To: Kristopher Byrd, Well Construction Manager
From: Tommy Laird, Well Construction Program Coordinator
Subject: Re-Review of Water Right Application G-18840
Date: May 23, 2024

Application # G- 18840 re-review

TO: Water Rights Section Date 6/20/2023
 FROM: Groundwater Section Travis Brown
 Reviewer's Name
 SUBJECT: Application G- 18840 re-review Supersedes review of 8/28/2019
 Date of Review(s)

A. GENERAL INFORMATION: Applicant's Name: Mayfield Farms, LLC County: MARION

This Drawdown Analysis

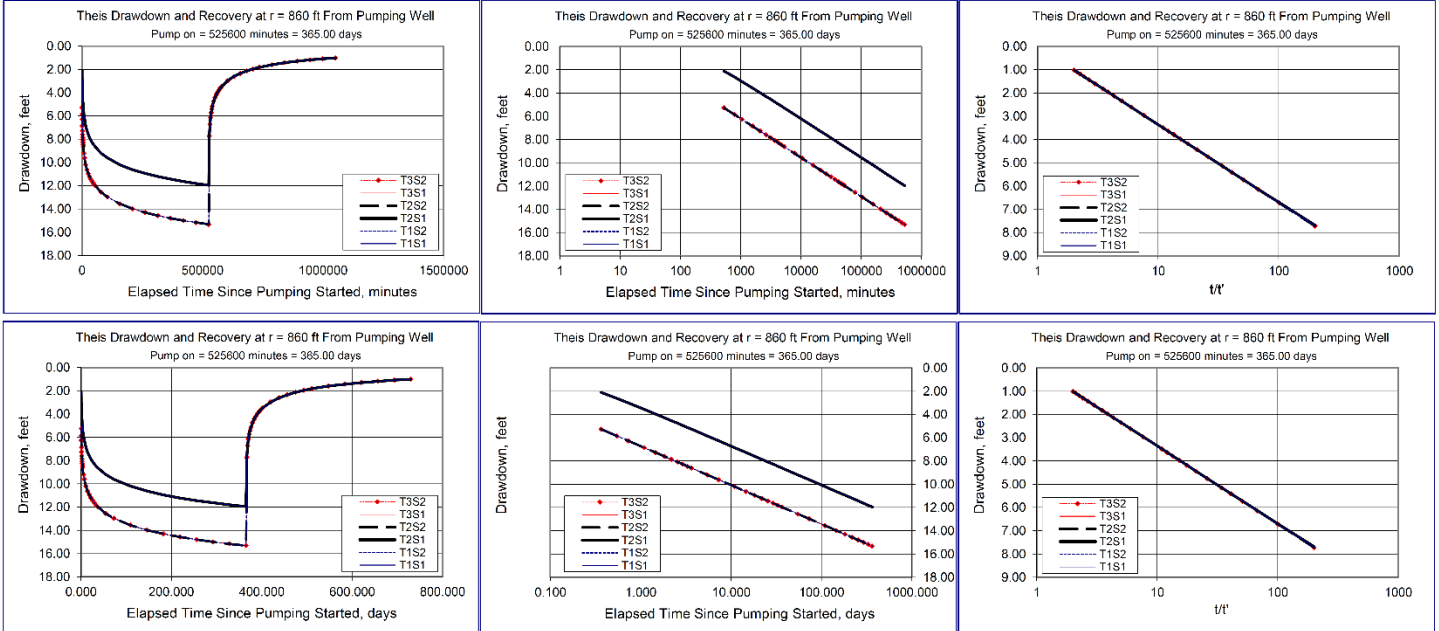
The nearest senior groundwater right producing from similar water-bearing zones as the proposed POA is MARI 143, authorized POA for Certificate 42114. MARI 143 is ~860 ft east of proposed POA 5. To assess the potential for injury to Certificate 42114 due to the proposed use, an analysis was conducted using the Theis (1935) equation for drawdown in a confined aquifer. Hydraulic parameters used for the analysis were derived from regional data and studies (Pumping Test Reports, Conlon et al., 2003, 2005; Iverson, 2002; McFarland and Morgan, 1996; Woodward et al., 1998) or are within a typical range of values for the given parameter within the hydrogeologic regime (Freeze and Cherry, 1979; Domenico and Mifflin, 1965). The applicant has noted in the Application that they have also submitted a Groundwater Registration Modification application (GR-MOD T-13221) which proposes to change the POA for Groundwater Registration GR-3351 to POA 1-5 as identified in this application. Per proposed GR-MOD T-13221, POA 1-5 would pump up to 0.25 cfs under GR-3351, in addition to the 0.45 cfs requested in this application. Therefore, the analysis used a combined rate of 0.7 cfs (~314 gpm) to assess potential injury to nearby senior users. **Results indicate that the proposed use is not likely to interfere with MARI 143 such that a senior groundwater user would be prevented from receiving water to which they are legally entitled (see Theis Drawdown Analysis, attached).**

Hydrograph - Spring

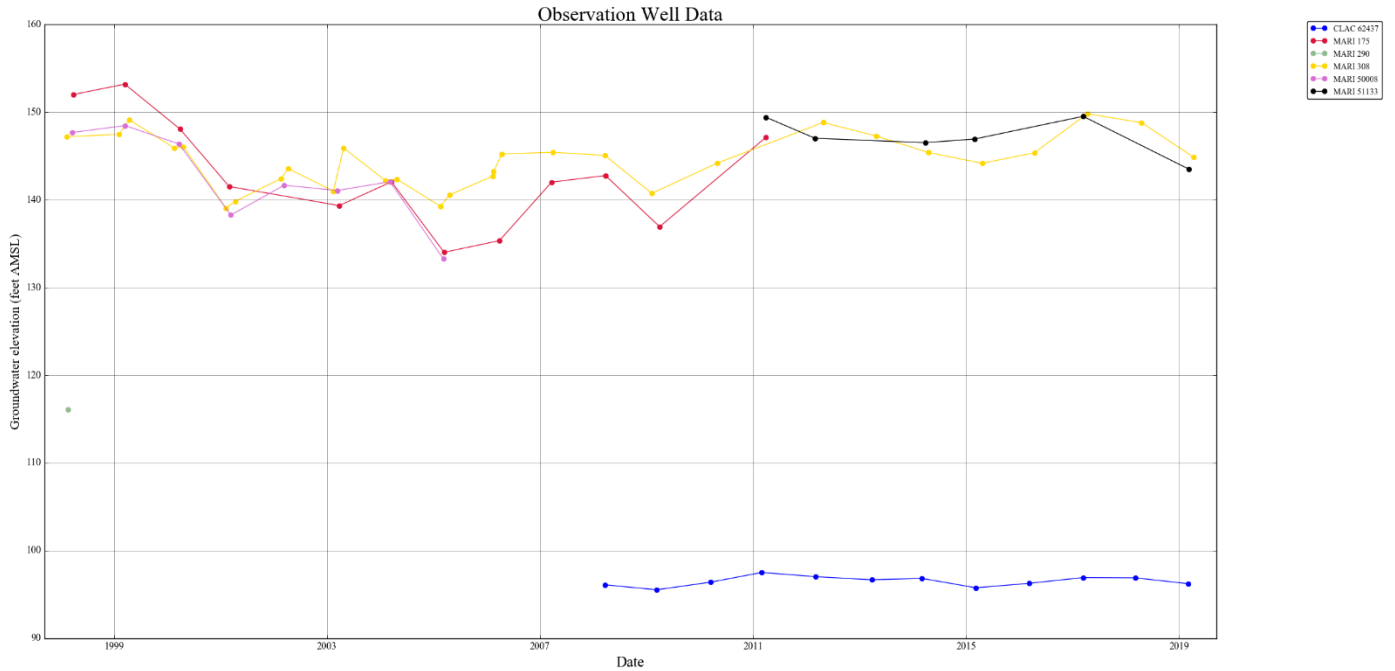
Hydrographs of water levels in the nearby alluvial aquifer system over the past two decades do not indicate widespread or persistent declines (see Hydrograph - Spring, attached). However, there do appear to be substantial (~30 ft or more) seasonal fluctuations in water level based on observations from a nearby State Observation Well (see Hydrograph – MARI 308, attached). Additionally, well completion statistics from the area indicate slight trends of deeper well completions and lower initial reported static water levels over time (see Well Completion Statistics, attached). **While there is not sufficient evidence**

to conclude that the proposed use would exceed the capacity of the resource, the Conditions specified in B1(d) and B2(c) are recommended to protect the resource and nearby senior users.

Well Completion Statistics – 3S/1W-32 & 33, 4S/1W-3 & 4

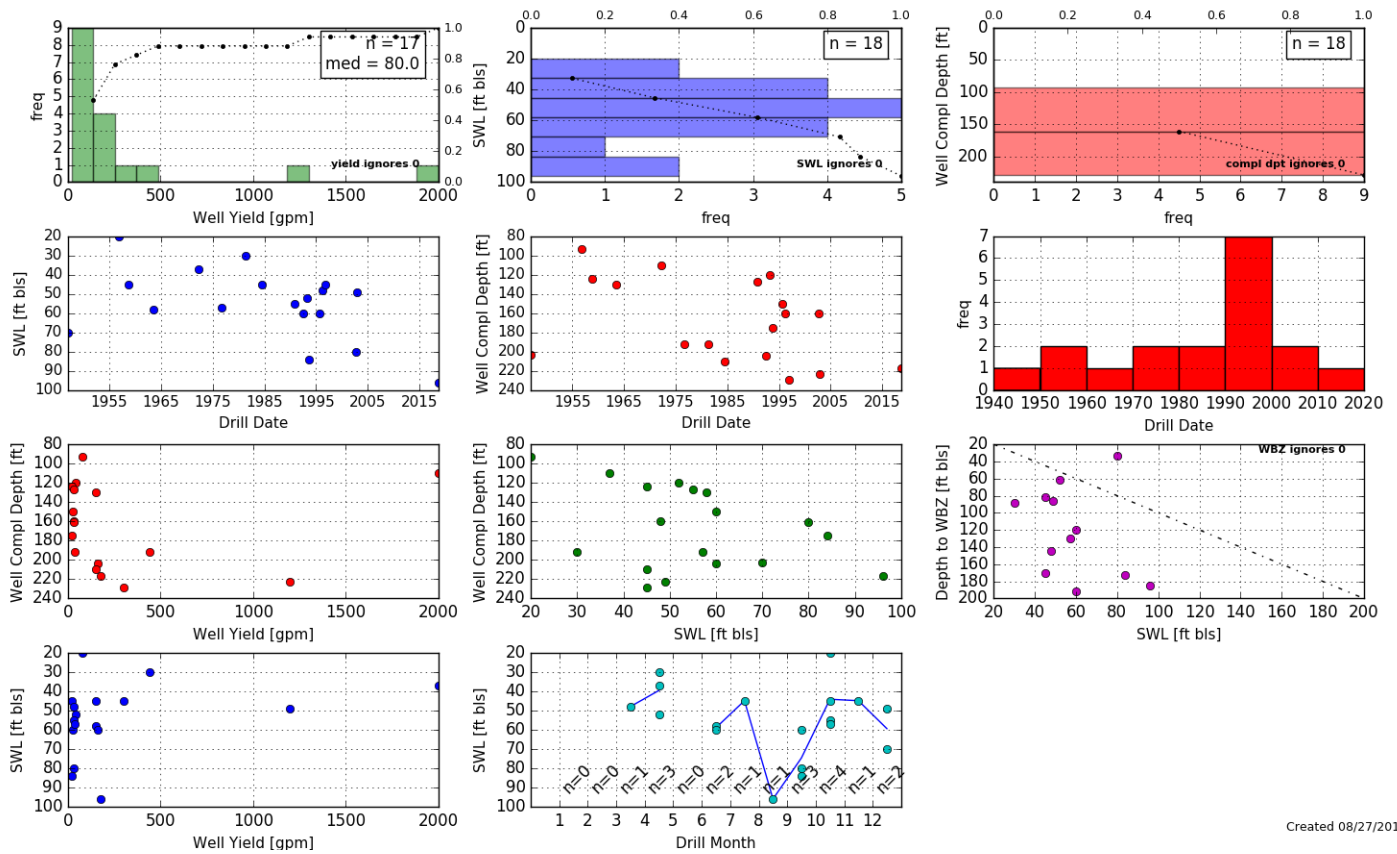
Basis for aquifer confinement evaluation: Reported static water level in MARI 68155 was greater than 80 ft above the noted water-bearing zone, indicating confined conditions. Well completion statistics from this area indicate that most completed wells have initial reported static water levels above the first noted water-bearing zone, also indicating confined conditions (see Well Completion Statistics, attached). Based on the available evidence, the aquifer appears to be confined in this area.

Stream Depletion Analysis – SW 1 (Willamette River)

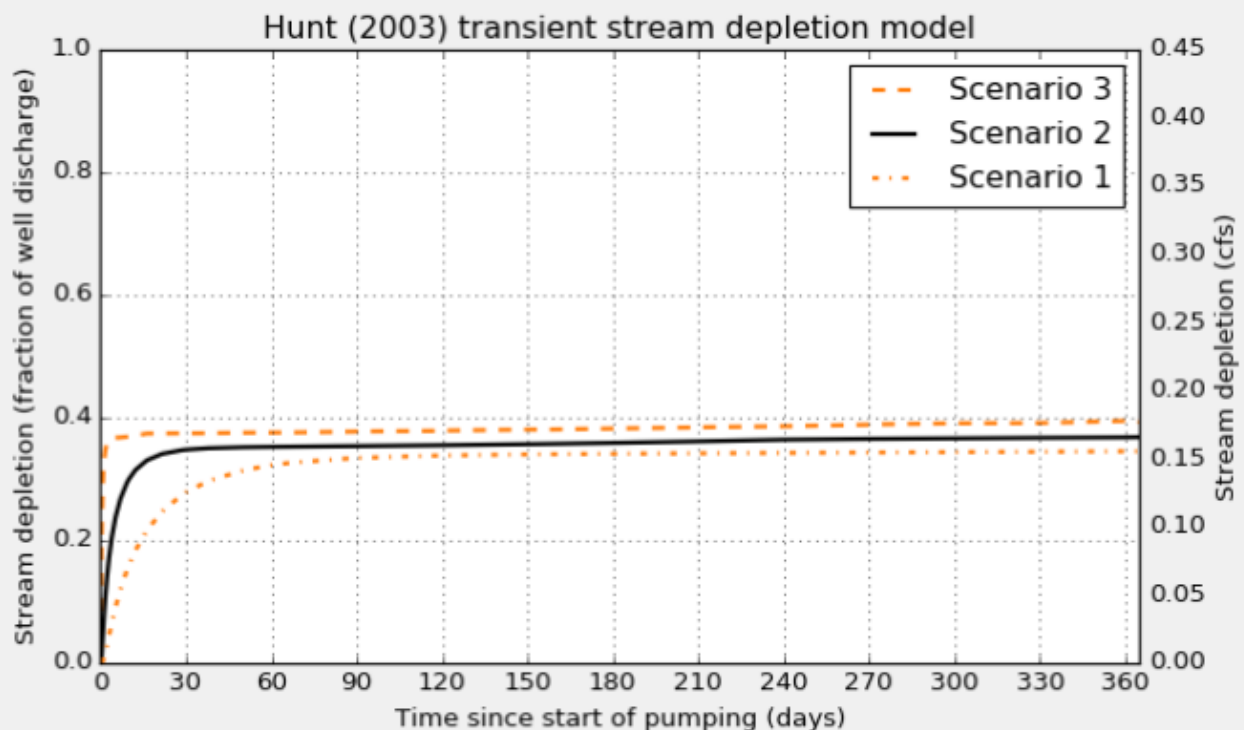
Comments: 3a: To assess the potential interference with surface water due to the proposed use, a stream depletion analysis was conducted using the Hunt (2003) analytical model. Hydraulic parameters used for the analysis were derived from regional data and studies (Pumping Test Reports, Conlon et al., 2003, 2005; Iverson, 2002; McFarland and Morgan, 1996; Woodward et al., 1998) or are within a typical range of values for the given parameter within the hydrogeologic regime (Freeze and Cherry, 1979; Domenico and Mifflin, 1965). Results of the analysis indicate that the proposed use will primarily impact SW 1 (Willamette River), with depletions of SW 1 most likely exceeding 25 percent of the rate of well discharge within 30 days of continuous use (see Stream Depletion Analysis, attached). The high relative rate of stream depletion is attributed primarily to the small intervening thickness of fine-grained sediments between the alluvial aquifer system and SW 1 (Willamette River) (i.e. a highly efficient hydraulic connection) and the confined nature of the alluvial aquifer. **Per OAR 690-009-0040(4)(d), the proposed use is assumed to have the potential to cause substantial interference (PSI) with SW 1 (Willamette River).**
